REA Briefing Sessions 2016

Part 3 – Common Non-compliance Item in Statutory Submission

Part 3 – Common Non-compliance Item in Statutory Submission

Form EE-LG Submission – Office Building xxE

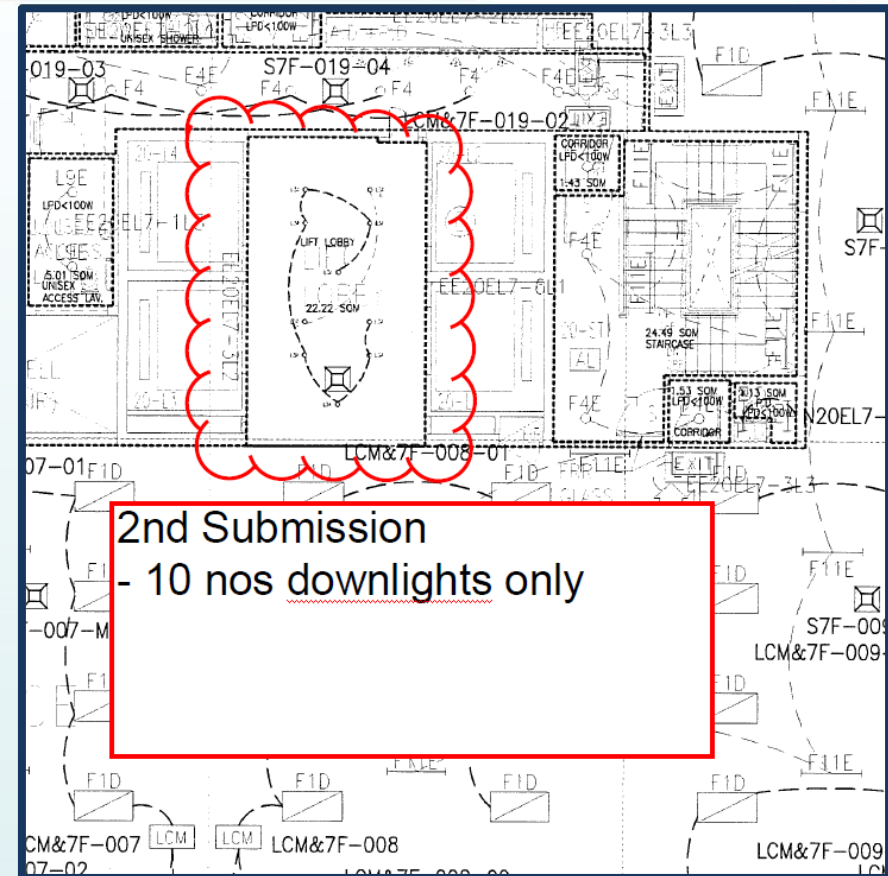
Lift Lobby LPD calculation:
 10 no. of downlight only, other light fitting excluded.
 Part 3, Form EE-LG, LED light strip not filled in

Lift Lobby LPD calculation (Re-submission):
 Omits lighting on plan to in line with the calculation.
 Light strip still ~~missing~~

Form EE-LG Submission – Office Building xxE

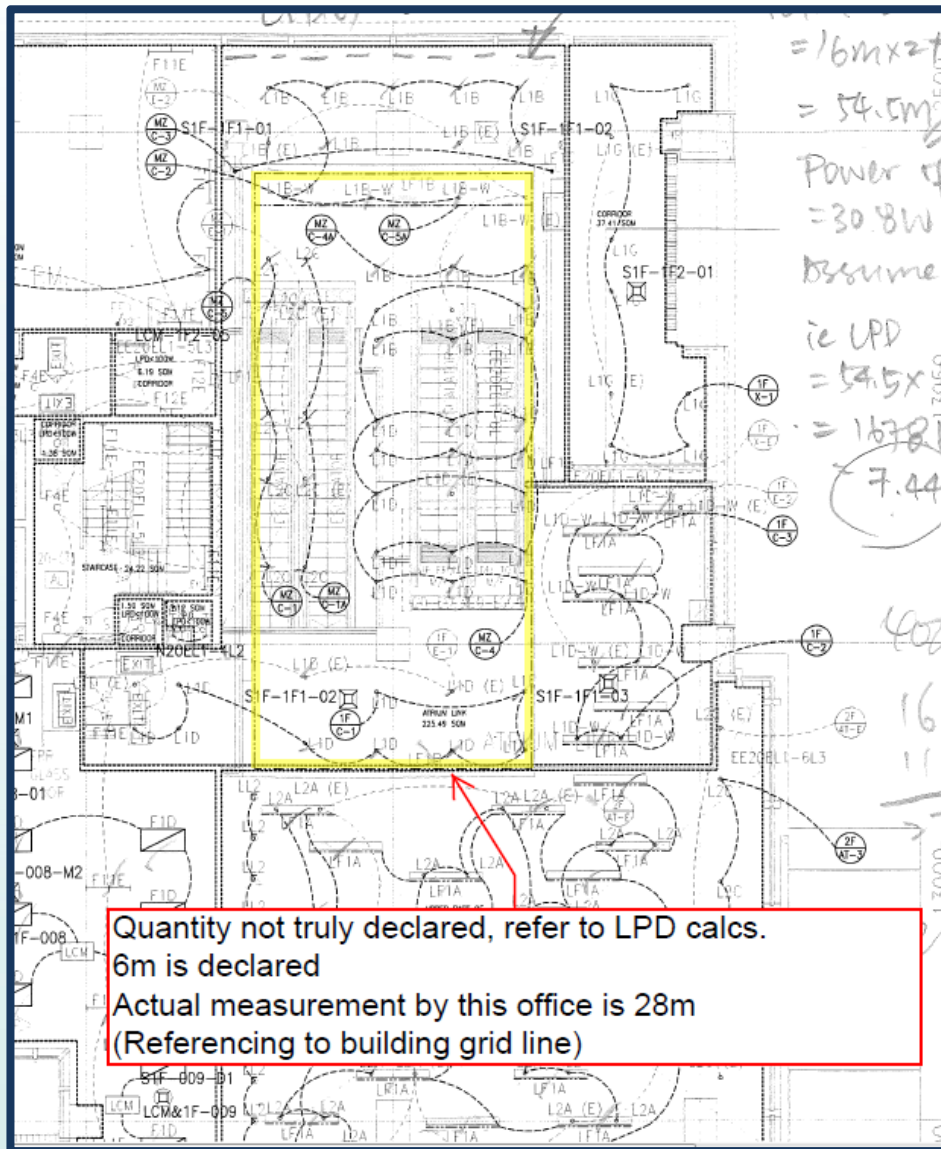
Obvious Measurement Error

Quantity not truly declared, refer to LPD calcs.
6m is declared
Actual measurement by this office is 28m
(Referencing to building grid line)

Form EE-LG Submission – Building H

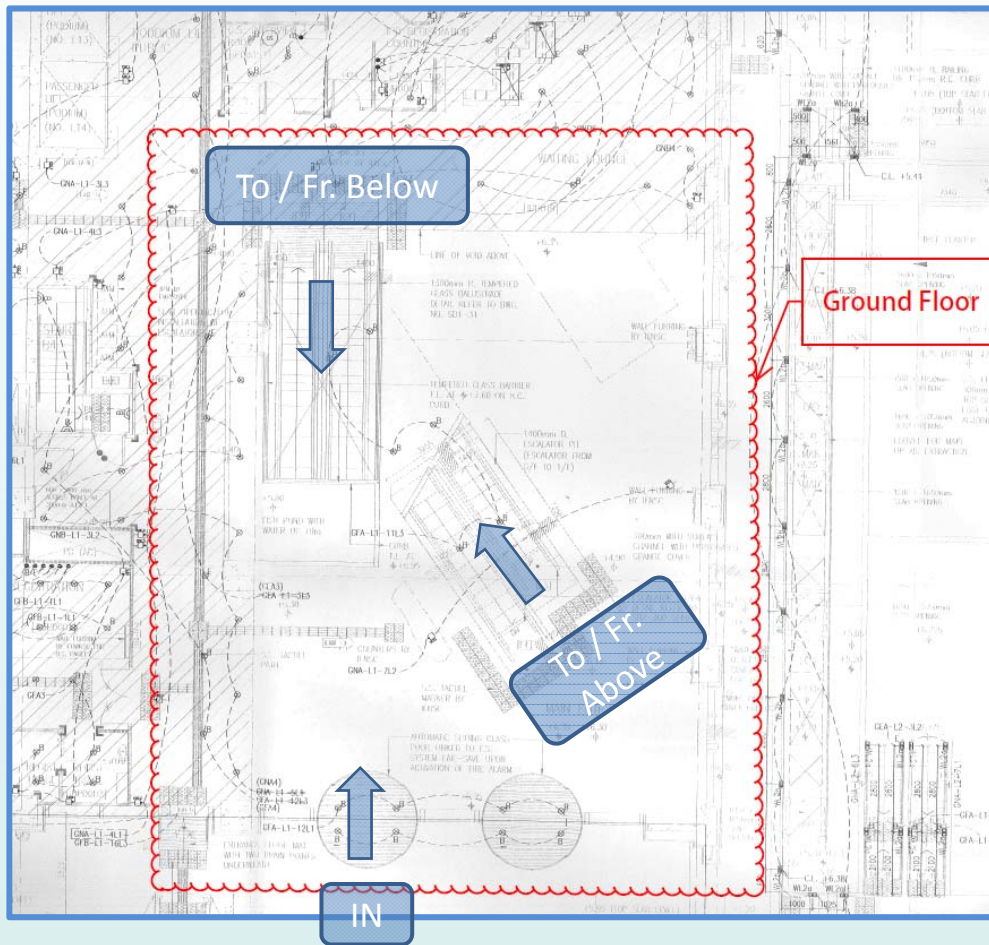
- Stage 2 submission
- Main Entrance
- Floor area: 280 m²
- Height: ~ 8 m
- Connection to 1/F & B1/F

Form EE-LG Submission – Building H

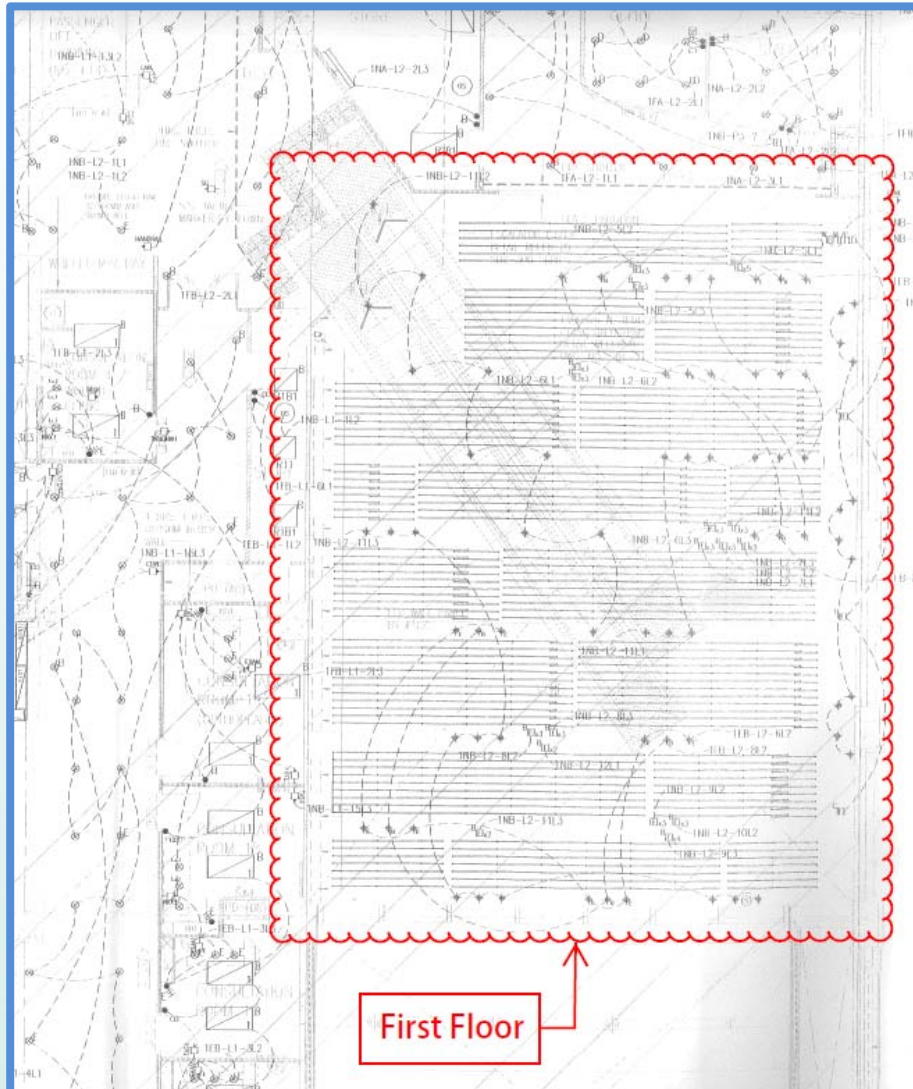
- Stage 2 submission
- Submitted only lighting layout
- REA/Design Architect regards the penal type ceiling light for decoration only
- LPD calculation NOT submitted
- Present the calculation after being requested

Downlights + Barrisol Stretch Ceiling (BSC)

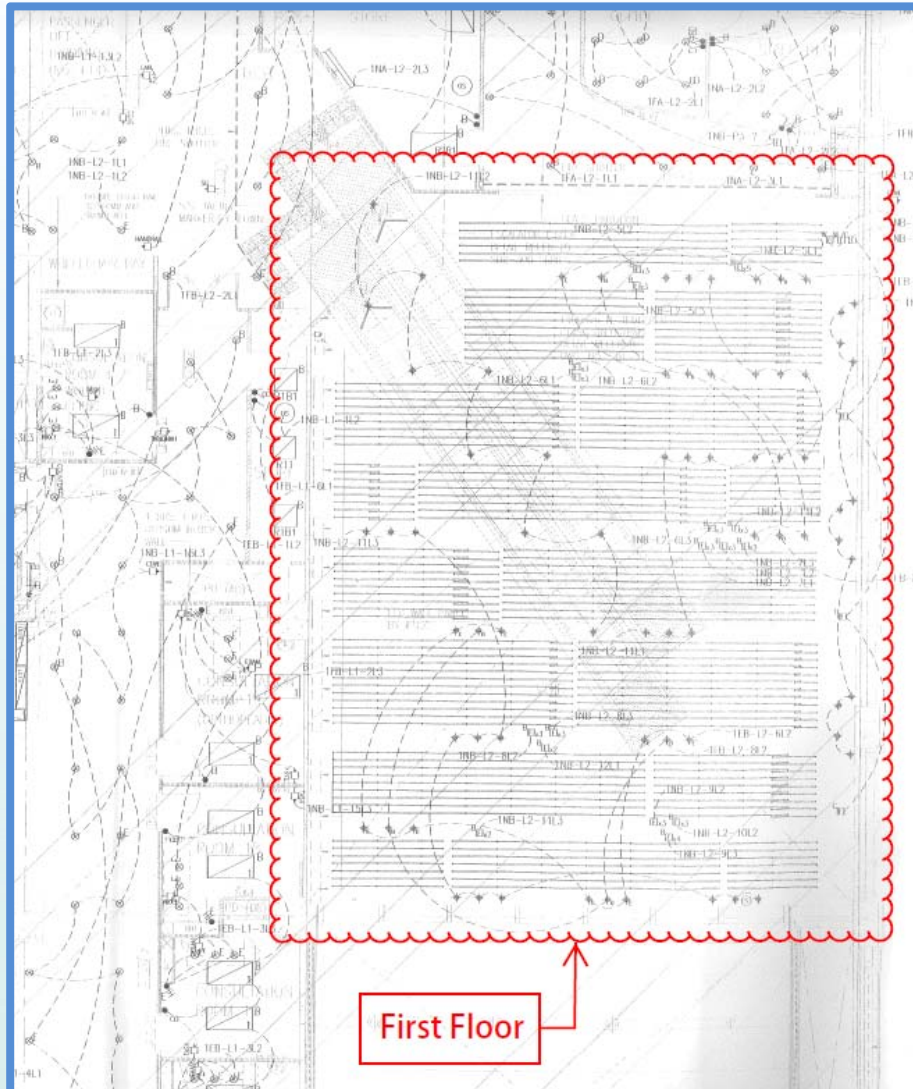
- Downlights:
 - ~ 80 No. x 40W Downlights
 - Avg. ~ 220 lx @ 0.85m AFFL
 - LPD: 12.6 W/m²
- BSC:
 - 85 No. 2ft LED Tubes (10 W each)
 - 850 No. 4ft LED Tubes (18 W each)
- Downlights + BSC:
 - Avg. ~ 1150 lx @ 0.85m AFFL
 - LPD: 70 W/m²
- Any more lighting NOT shown? Vertical surface, u/n escalator.

Vertical Lights

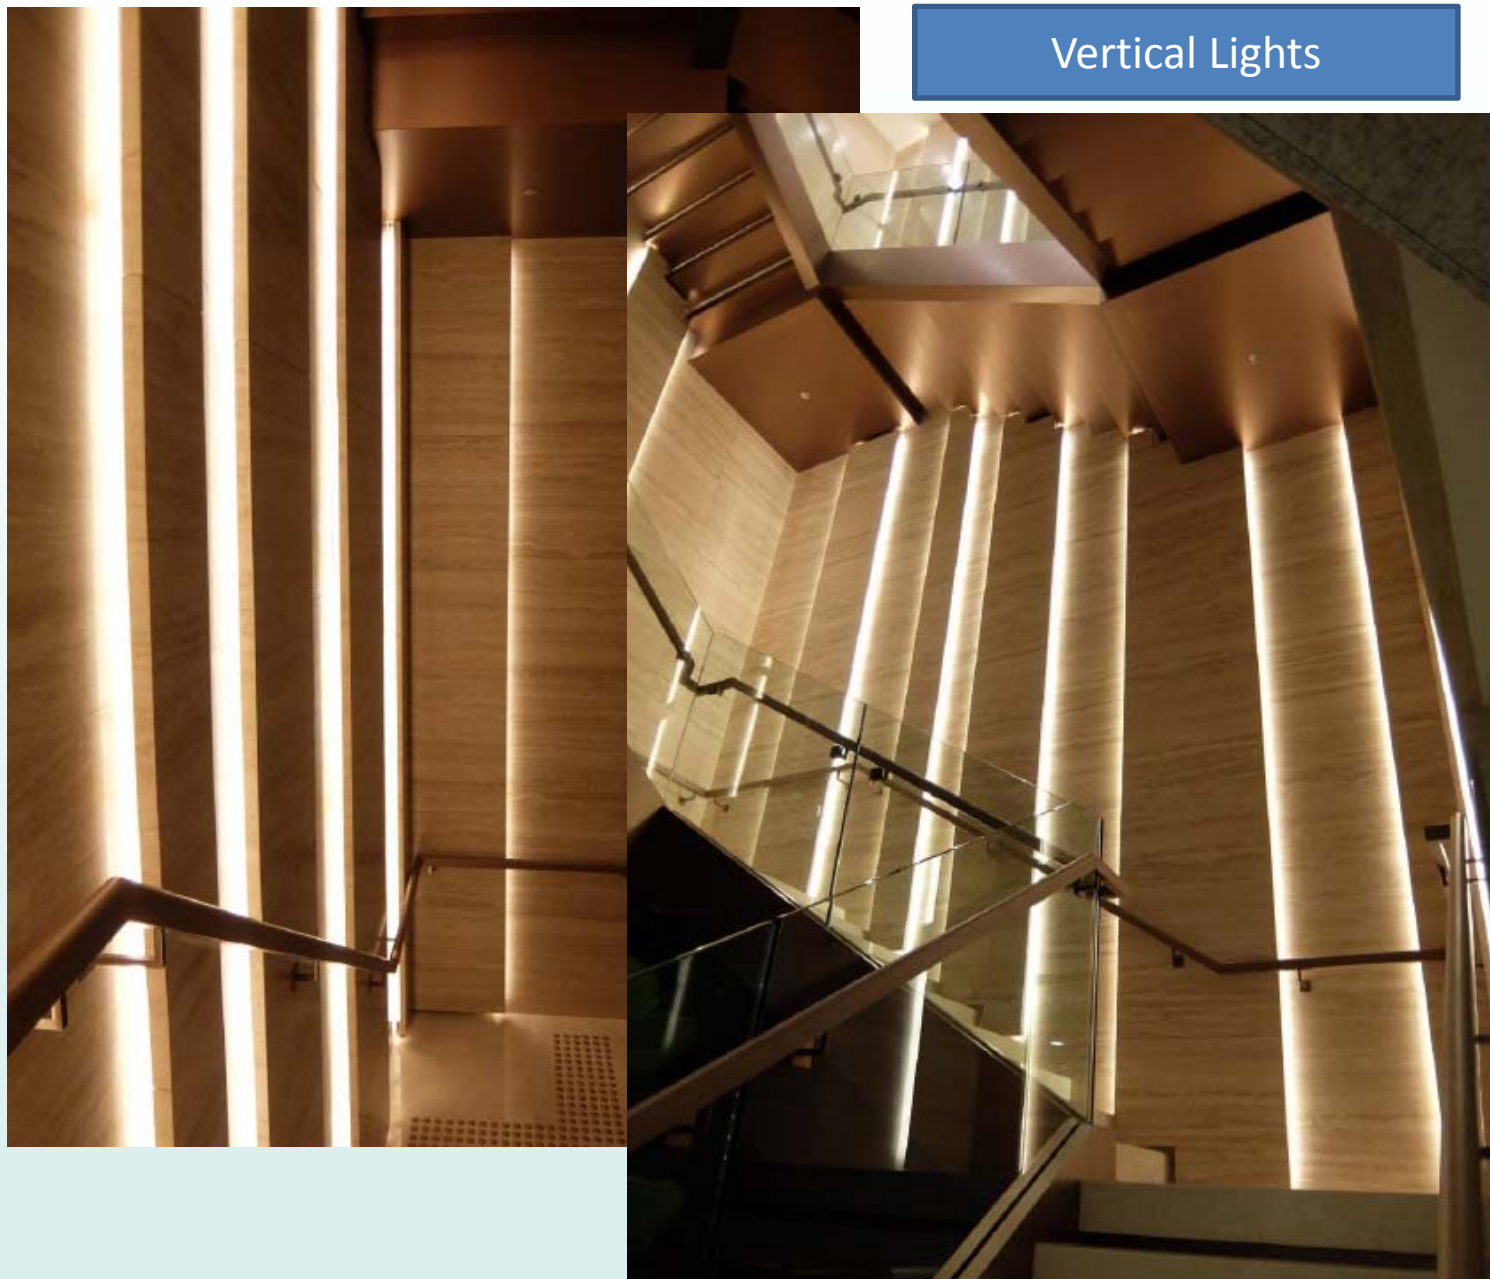
- Wall Panels with LED Strip Light (~120m) throughout the access stair
- LED Strip Light contribute substantially uniform level of illumination throughout → LPD limit applicable
- REA/Owner's arguments:
 - Presence of downlight, strip light solely for decorative; ❌
 - Use dimmer to "Tune Down" strip light power to suit LPD limit ❌
- Change the power/m to suit.

- Lighting on vertical surface is also part of the lighting installation
- Submit elevation as necessary
- Lighting solely for decorative use shall also be shown on drawing.
- Highlight on plans
- Justify with site photos showing lighting effect or submit photomontage
- Part 3 (EE-LG) fill in with LPD of decorative light
- Initiate early discussion for case in doubt, especially small lighting space such as passenger lift lobby, FOH toilets, corridor etc.

Form EE-LG Submission Poor Submission Drawing Quality

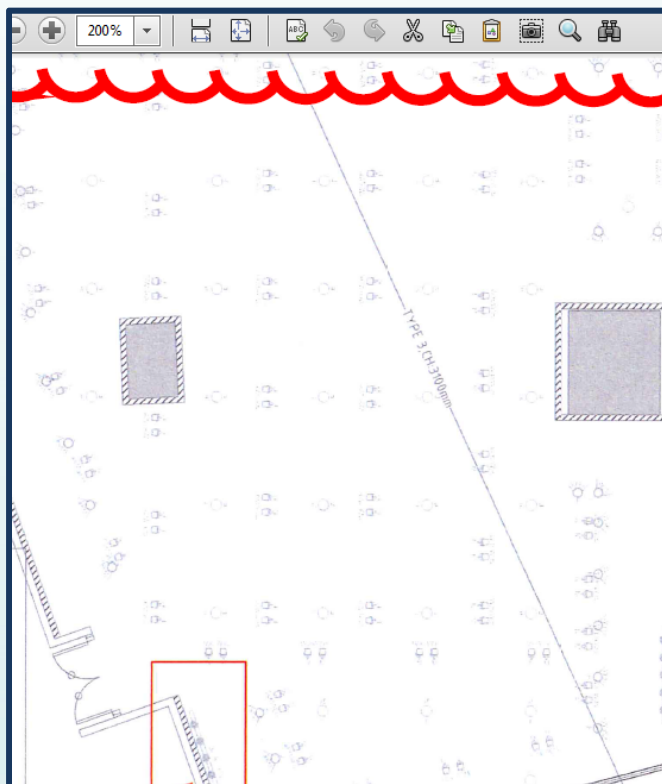
Extract of Lighting Layout
Only legend is readable

Form EE-LG Submission Poor Submission Drawing Quality

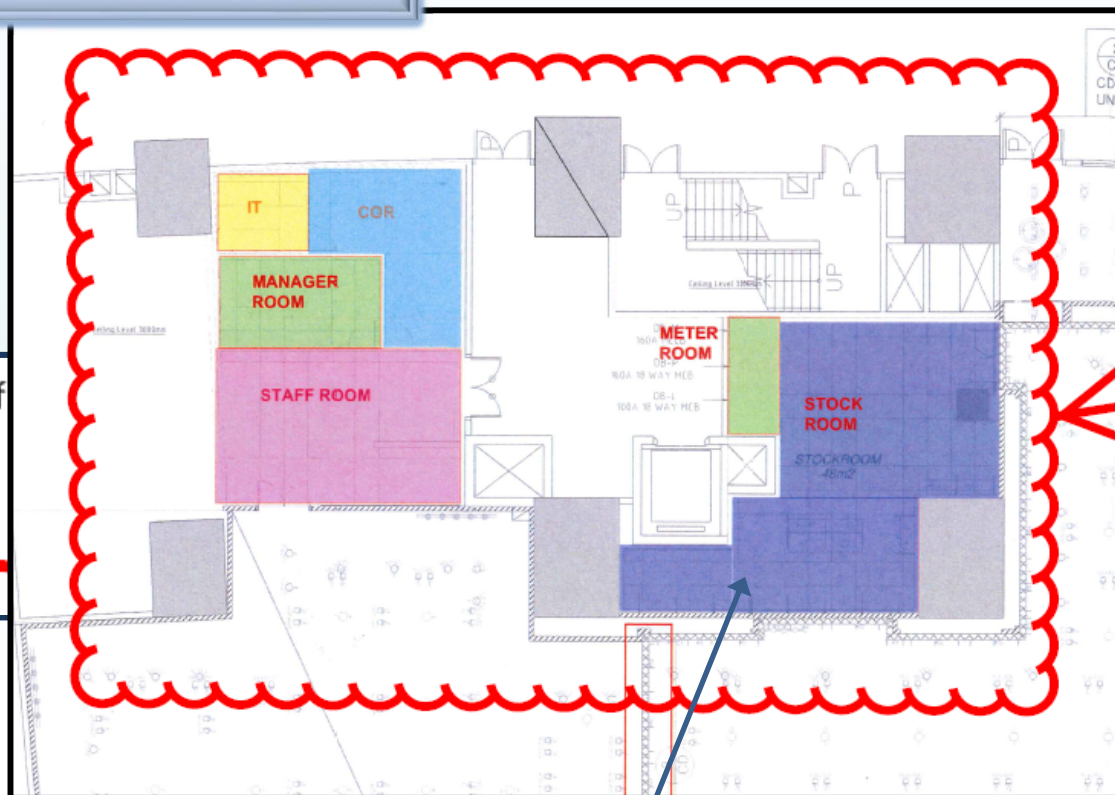
Lighting layout shows
NO light fittings

Form EE-LG Submission Poor Submission Drawing Quality

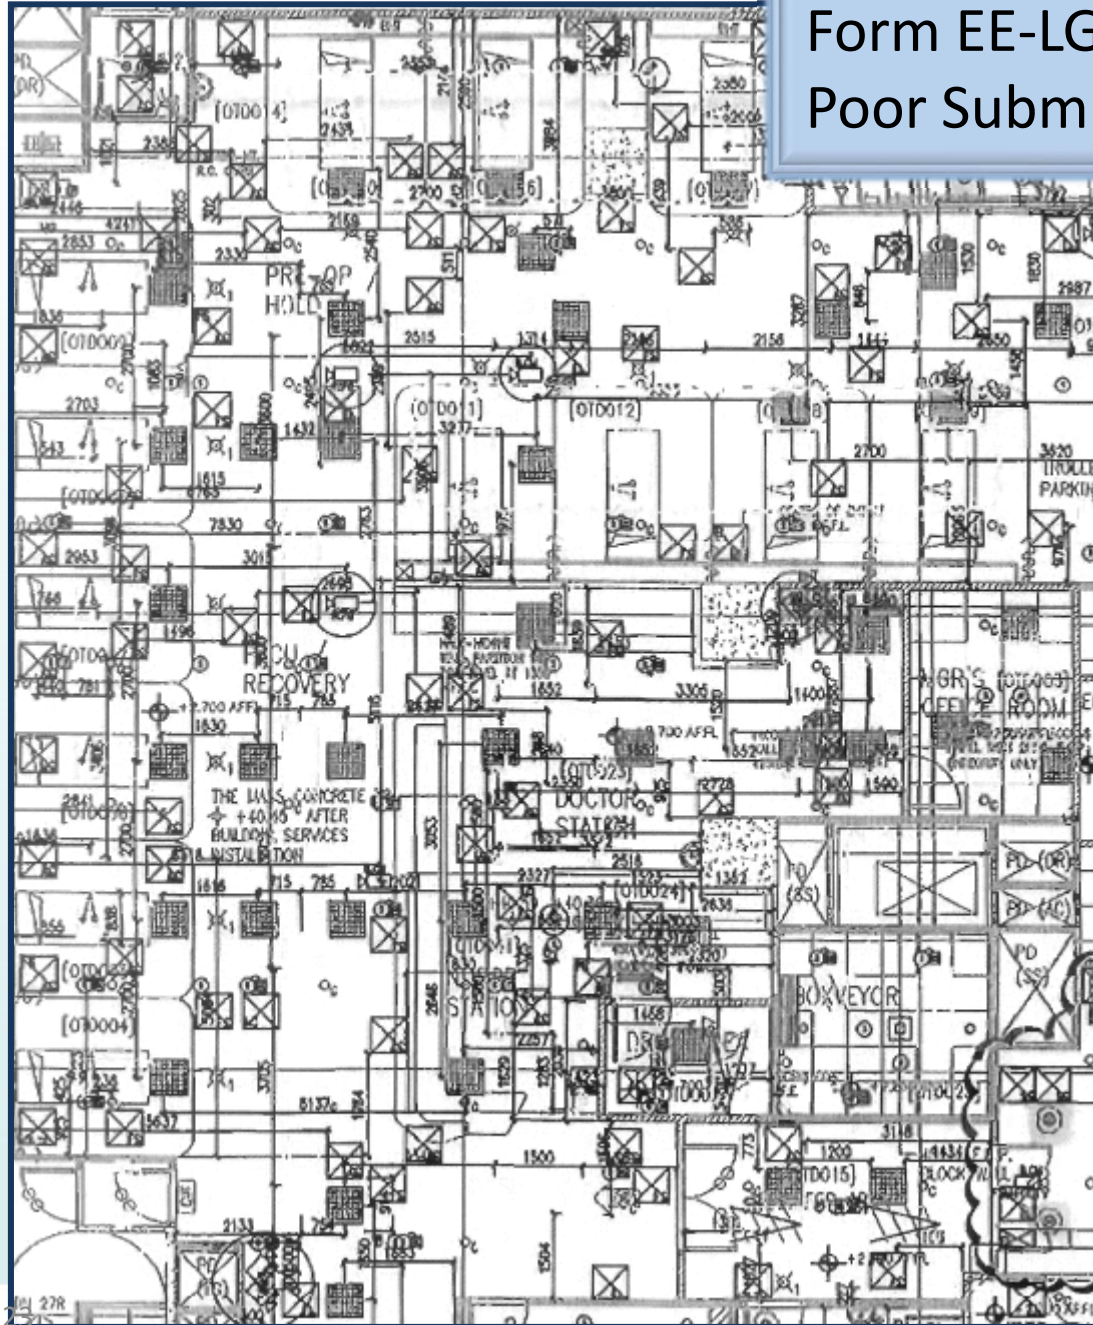
- Twisting Lighting Points
- Additional Lighting Points
- Relocation Lighting Points

Coloured legend but submit B&W drawing??

New Building
As-fit drawings shows "Existing",
"Additional" and "Relocated" Lighting
Point??

**Compliance data must come from
traceable information**
